Birchland Park Middle School

Town of East Longmeadow ADA Transition Plan

October 2025

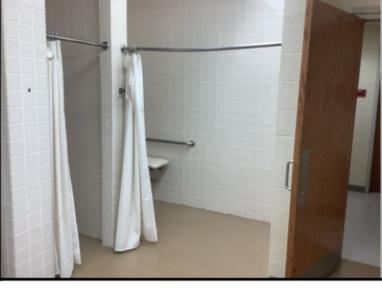
59	By Secondary Entrance - South Side/ Bus Drop-Off	Ext.	-	Curb Ramp	Blended Transition		Running slope is > 1:12 (8.33%) Curb ramp flares > 1:12 (8.33%) (if no landing)	9.8% 9.9%	Reduce running slope to be no steeper than 1:12 (8.33%). Reduce slope at curb ramp flares to be no steeper than 1:12 (8.33%).	1	-	-
60	By Southeast Corner of Building	Ext.	-	Curb Ramp	Blended Transition		Curb ramp flares > 1:12 (8.33%) (if no landing)	8.9%	Reduce slope at curb ramp flares to be no steeper than 1:12 (8.33%).	1	-	-
